**COUNTY VACATION
& SUBDIVISION STAFF REPORT****Date: November 7, 2013****NAME**

LHRP 2 Commercial Park Subdivision

Request to vacate a 15' wide drainage easement, two (2) 20' wide drainage and utility easements, a 24' wide ingress/egress easement, a 25' wide drainage easements/detention/common area, and a detention/common area; and create two (2) legal lots of record from three (3) existing legal lots of record.

SITE PLAN

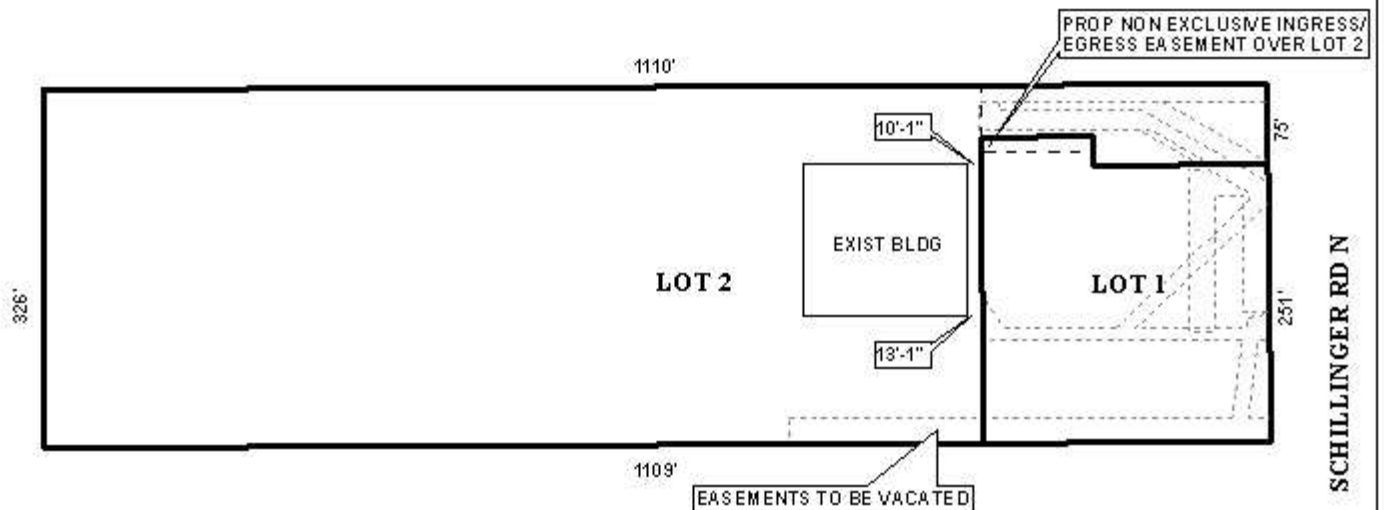
Regarding the creation of the new lots, the plat depicts the proposed 2-lot, 8.3± acre subdivision. As stated previously, the site is currently three (3) legal lots of record. The proposed lots appear to meet the minimum size requirements as regulated by Section V.D.2. of the Subdivision Regulations. The sizes of the lots are not depicted in square feet or acres. If approved, the lot sizes should be provided on the Final Plat in square feet and acres, or a table with the same information should be provided.

The site is located on Schillinger Road North, which is a major street. As a major street, there should be a 100' right-of-way. The plat depicts a previous acquisition of right-of-way along the site's frontage to provide approximately 70' from the centerline of Schillinger Road North; therefore, no dedication would be required.

It should be noted that the proposed Lot 2 is a flag lot, with a 75' wide pole. The Planning Commission approved LHRP Subdivision with a flag lot at its April 4, 2013 meeting with a 33'± wide pole, therefore a waiver of Section V.D.1. of the Subdivision Regulations may be appropriate.

The 25' minimum building setback is not shown for either lot, and should be illustrated for both lots on the Final Plat, if approved.

While the applicant is proposing to vacate an existing ingress/egress easement, there is a new ingress/egress easement which would provide both of the proposed lots with access to Schillinger Road North, therefore the development should be limited to one shared curb cut to Schillinger Road North, with said curb cut to be located on the proposed Lot 2, with the size, design, and location of the curb cut to be approved by Mobile County Engineering and conform to AASHTO standards.

- 1) depiction of the lot sizes in square feet and acres, or provision of a table on the Final Plat with the same information;
- 2) illustration of the 25' minimum building setback for both lots;

- 3) placement of a note on the Final Plat limiting the development to one shared curb cut to Schillinger Road North, with said curb cut to be located on the proposed Lot 2, with the size, design, and location of the curb cut to be approved by Mobile County Engineering and conform to AASHTO standards;
